Draft Final Decision Document
for the Interim Response Action
for the Improvement of the North Boundary System
at Rocky Mountain Arsenal
Via Construction of Groundwater Recharge Trenches

June, 1988

RESPONSE TO US EPA REVIEW COMMENTS
ON PROPOSED DECISION DOCUMENT FOR
THE INTERIM RESPONSE ACTION FOR THE
IMPROVEMENT OF THE NORTH BOUNDARY SYSTEM
AT ROCKY MOUNTAIN ARSENAL VIA CONSTRUCTION
OF GROUNDWATER RECHARGE TRENCHES

Figure 3. Generalized Alluvial Groundwater Flow Across RMA

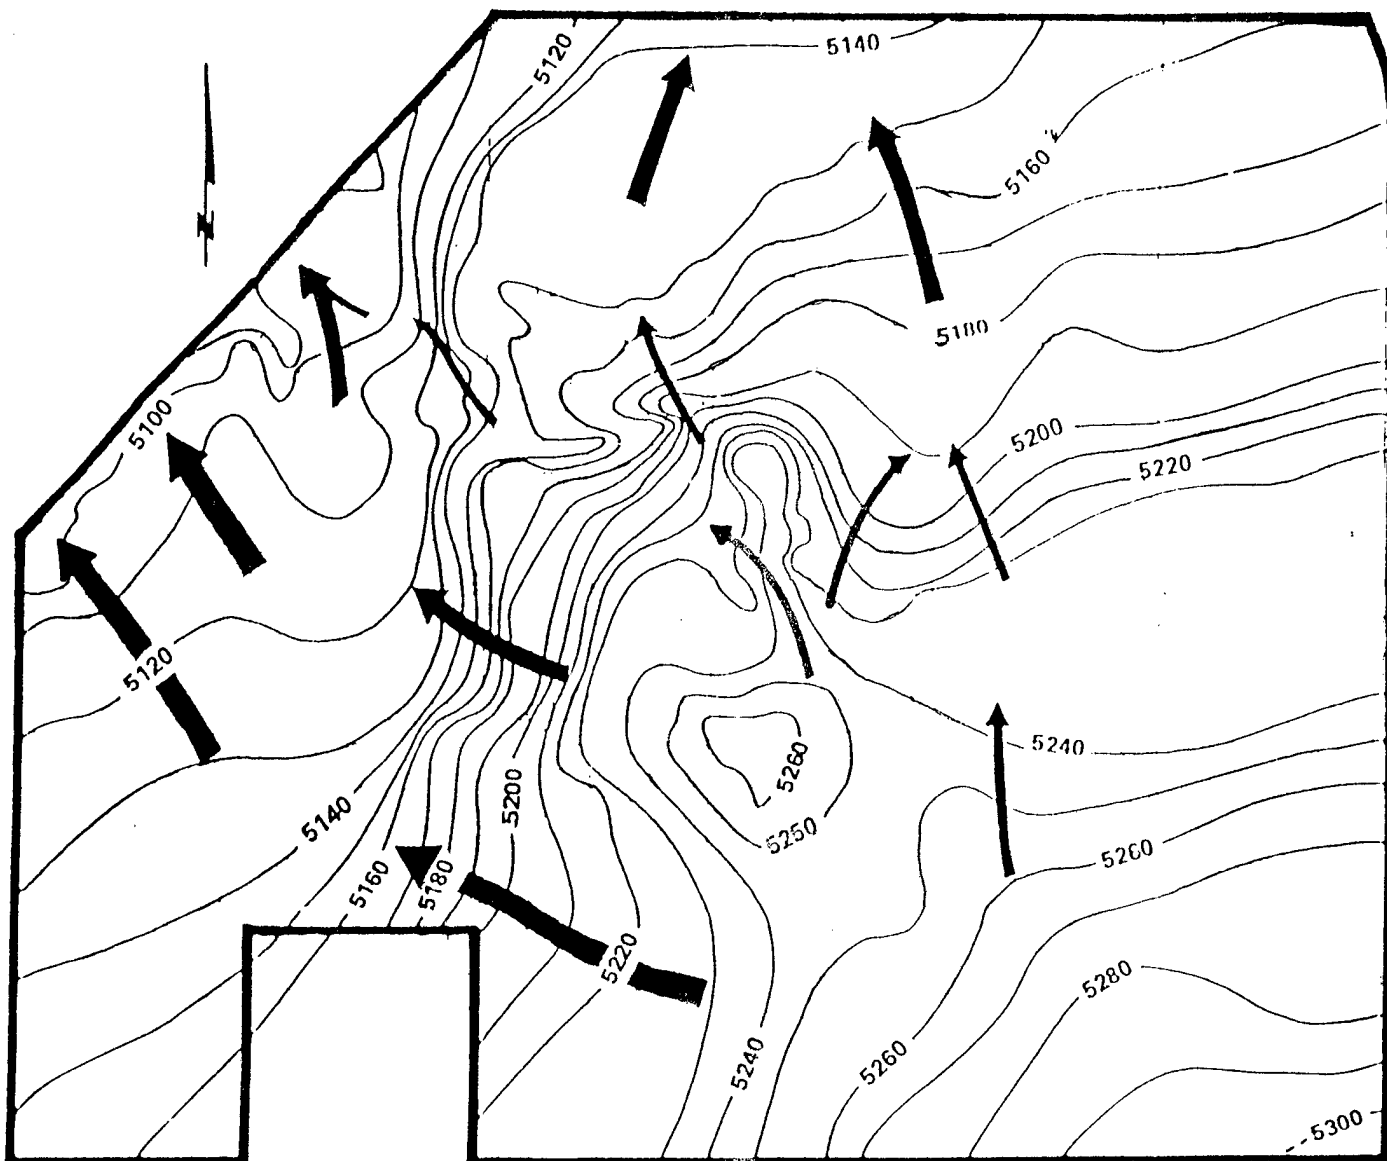
3. Pg. 2, para. 3. The second sentence should indicate that, generally alluvial groundwater beneath RMA flows from southeast to northwest and that Figure 3 represents generalized alluvial groundwater flow across RMA. Emphasis added.

4. Pg. 5, Figure 3. See Specific Comment ³/₈.

3. Page 2, paragraph 3. Emphasize text to clarify generality.

4. Page 5, paragraph 3. See specific comment 3.

Response: The text shall be modified as follows: "Alluvial groundwater beneath RMA generally flows from southeast to the northwest. Figure 3 represents the generalized alluvial groundwater flow across RMA."

Response: The description for Figure 3 shall be modified as follows: "Generalized Alluvial Groundwater Flow Across RMA."
